# DETAILED CONSERVATION COMMISSION AGENDA

Date: Thursday, January 27, 2022

### 1. (7:00) 152 Suffolk Rd – NOI – backyard pool, sports court, patio, and greenhouse – DEP #239-911

**5. (8:15) Hammond Pond Parkway – NOI – roadway and corridor improvement -- DEP #239-???**

NOTES:  
 1. PROVIDE AND MAINTAIN SILT SACKS IN ALL EXISTING AND PROPOSED CATCH BASINS WITHIN THE LIMIT OF WORK FOR THE DURATION OF CONSTRUCTION.

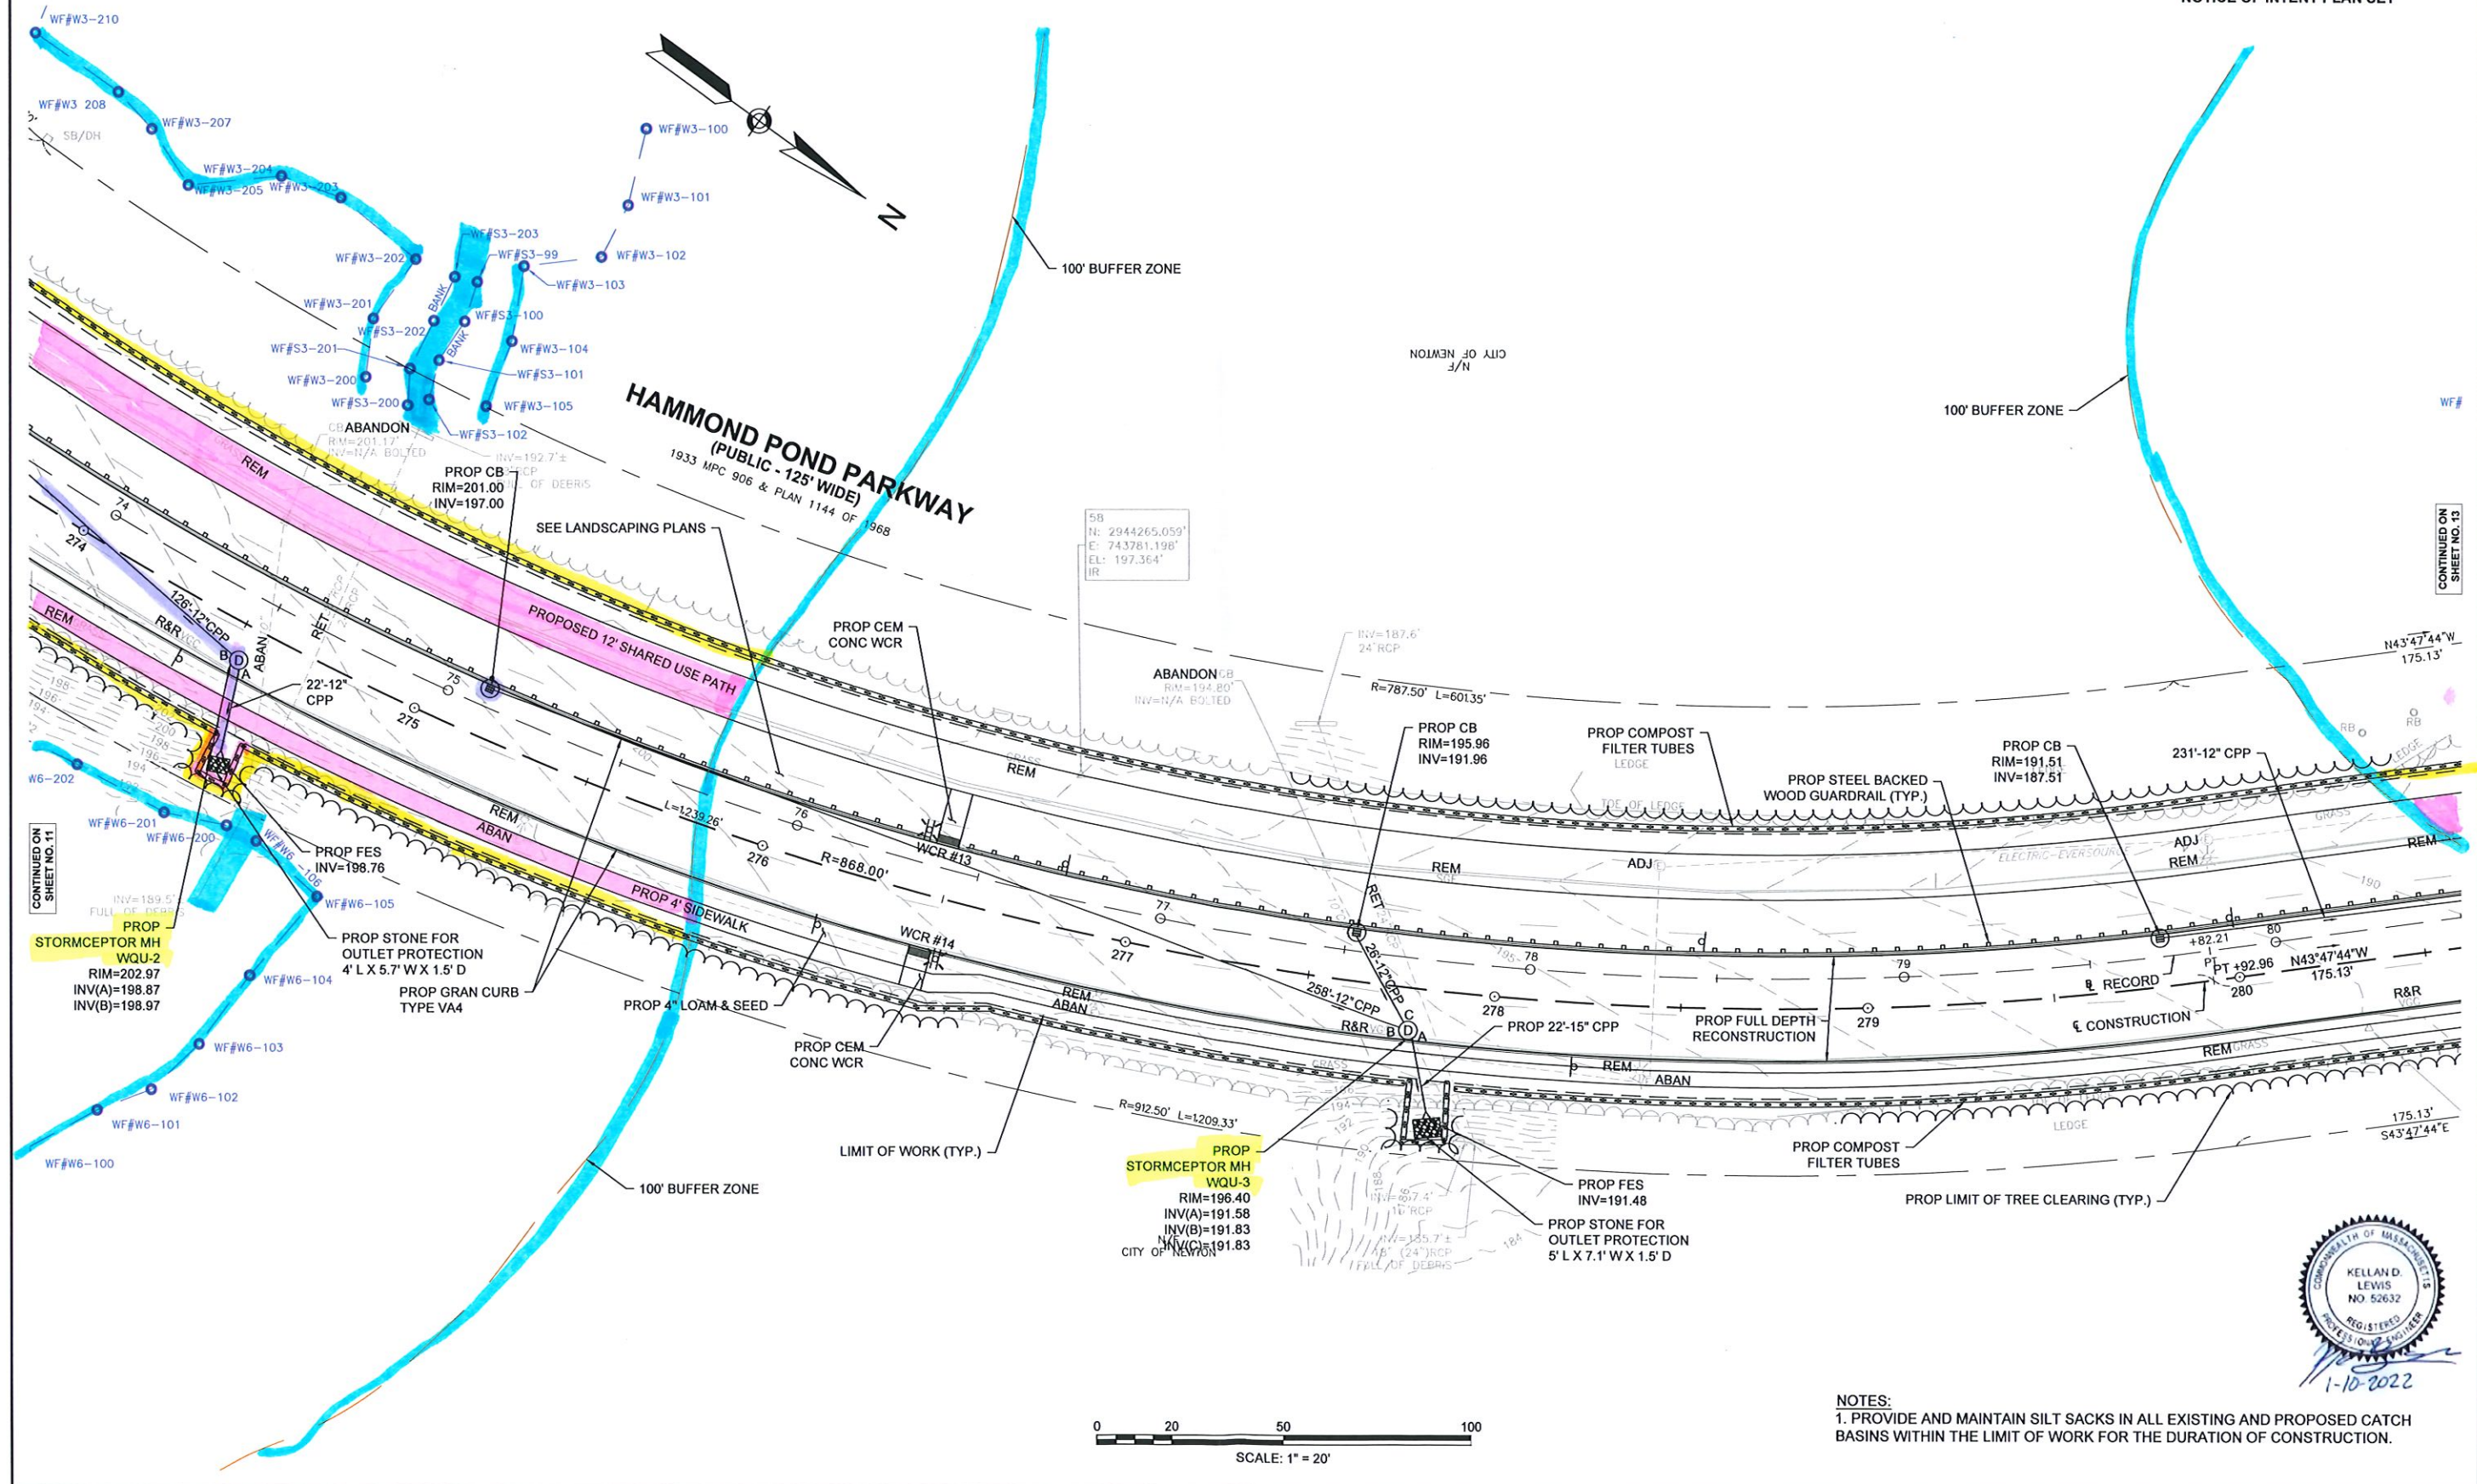
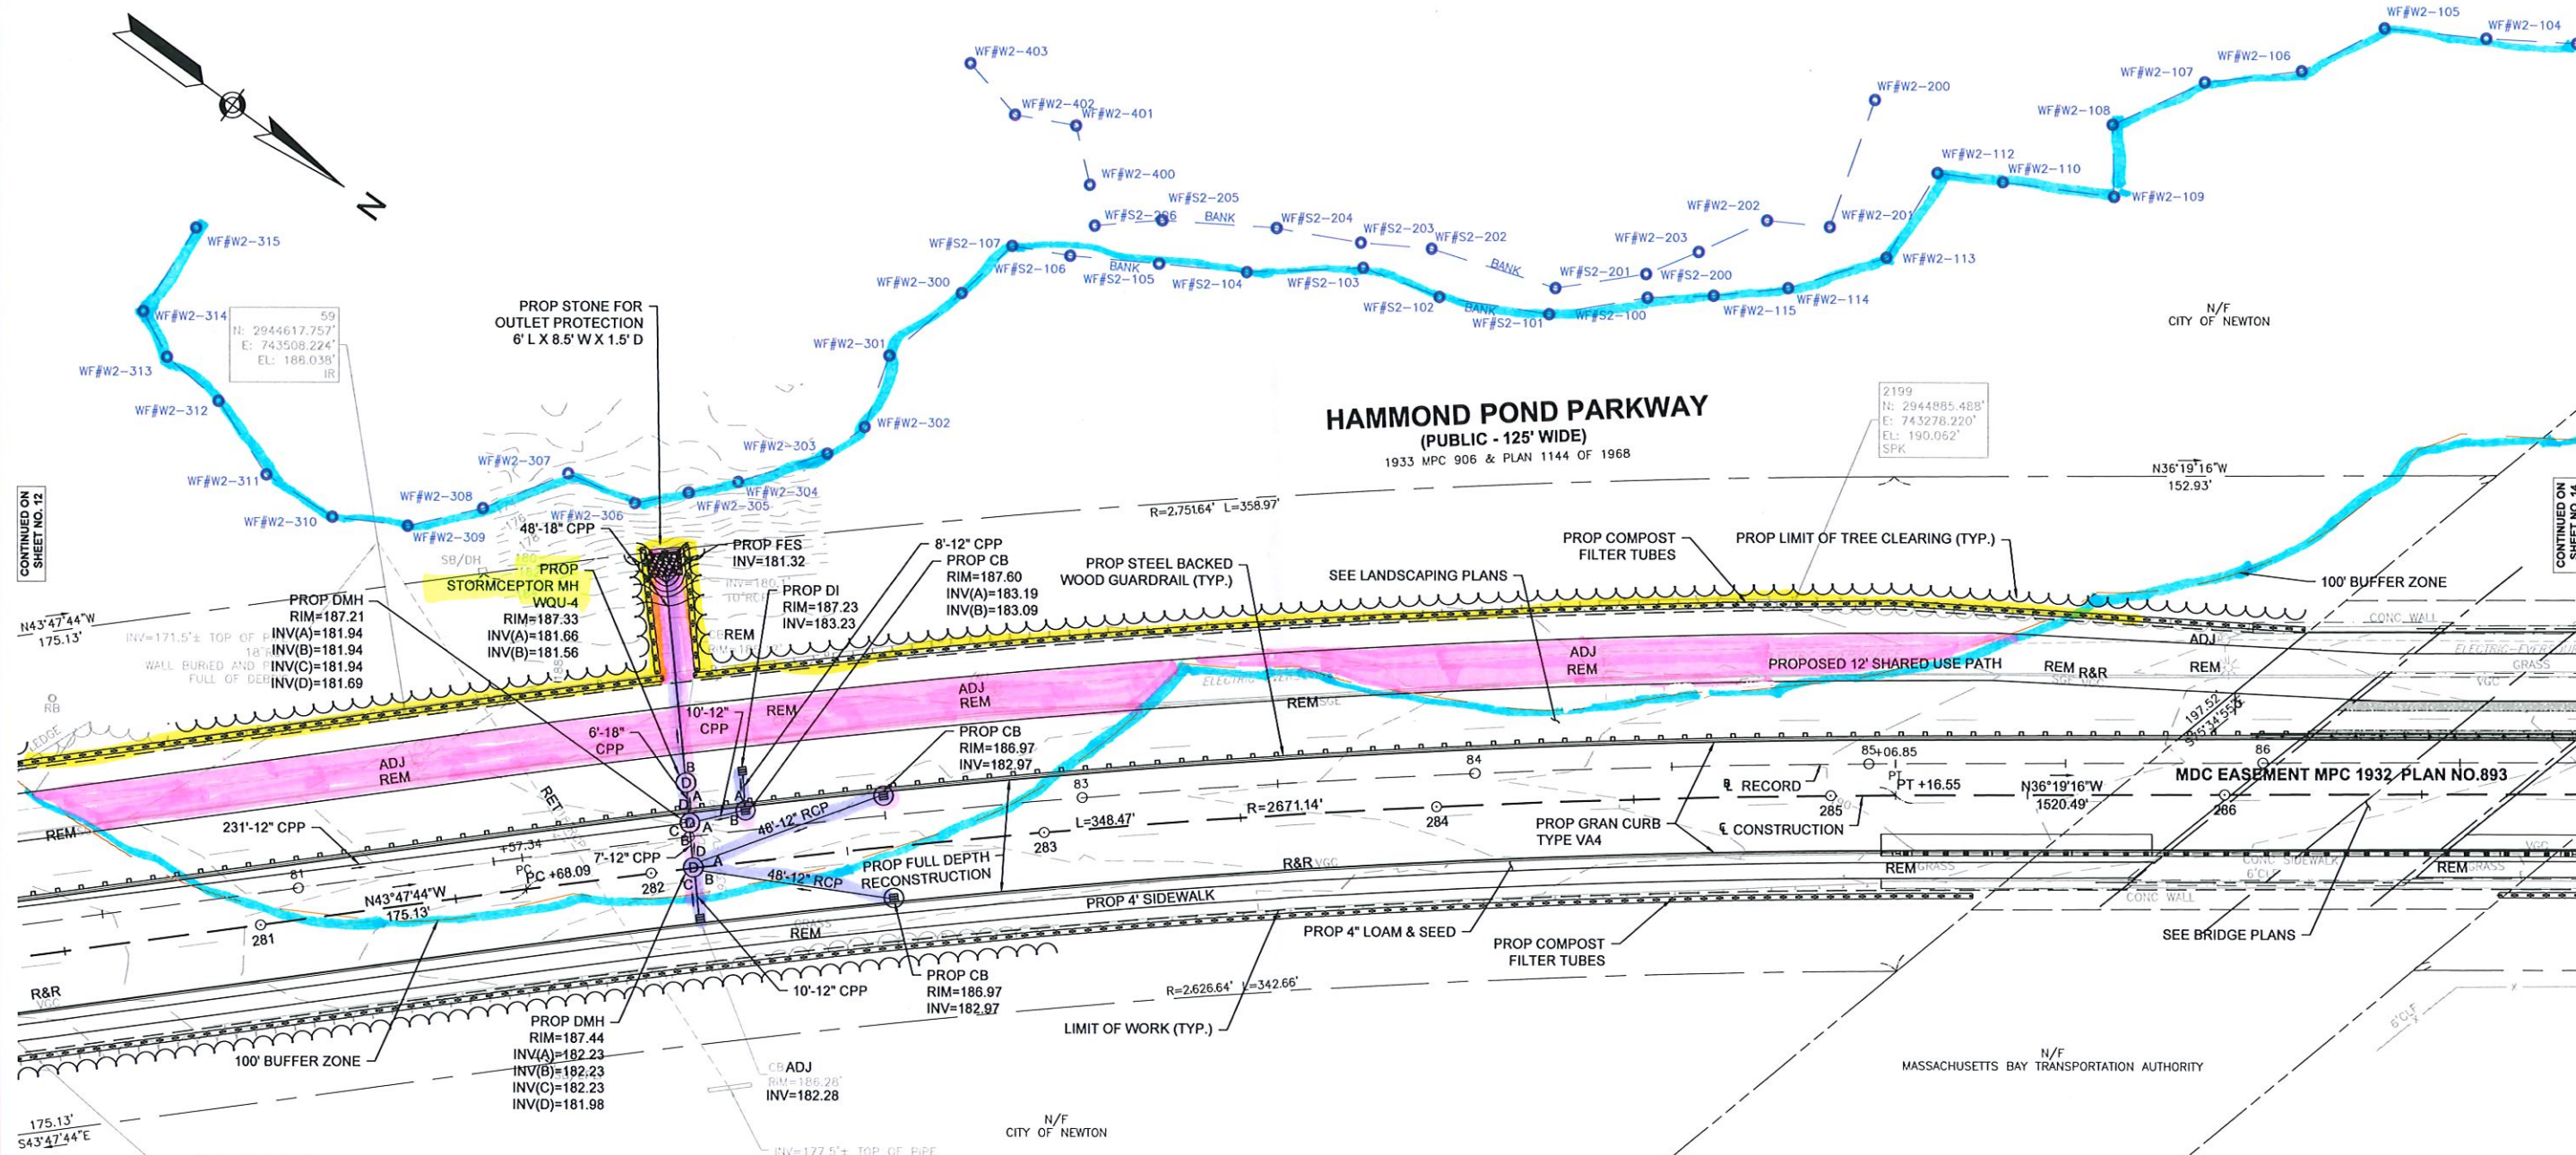
- Staff sought and received revised plans with improved legibility.
- The majority of the alterations within jurisdictional wetland areas are within degraded and disturbed areas (i.e., within the existing roadway and grass/dirt shoulder – “inboard of the existing guardrail”). Overall “paved” area will be reduced.

- The plans provided are very “conceptual” and identified as “not for construction”. More detail may be necessary
- Questions:

- If areas clearing (and grading?) along the edge of the tree line are required to construct the shared use path, those areas should be clearly identified on the plans.

- There will be significant grading at the northeast corner of the new parking area, yet no new grade lines are shown and it appears that insufficient space is provided for side slopes. How will this area be addressed?
- On Landscape Plan sheet 5 there is a “limit of grading” label that appears to be on the property line. It should be removed.
- There is no erosion control/limit of work shown that would protect the “island of trees” near Hammond Brook. That should be added.
- Will there be any invasive control efforts?

- Stockpiling areas should be identified on the plans.

- Compost sock will not provide sufficient erosion controls around the new stormwater discharge points (excavation in steep slopes) and the parking lot construction area (where significant fill is being brought in on an existing steep slope). Erosion control must be entrenched silt fence and staked compost sock.
- Will the road remain open during construction?
- When the old stormwater system is abandoned, will there be any disturbance outside the street layout?
- Will there always be a functioning stormwater collection and distribution system?

- There aren't details of the stormwater discharge points, but the plans indicate riprap aprons 5' L X 7.1' W X 1.5' D. How will the riprap be retained on steep slopes?

- Staff Recommendation: Once all questions are answered and concerns addressed and whenever the Commission feels that the plans are adequate for the Commission's purposes, vote to close the hearing and issue an OOC with the following special conditions:

- Stockpiling shall ...
  - Outfall details must ...
  - An invasives control plan shall ...
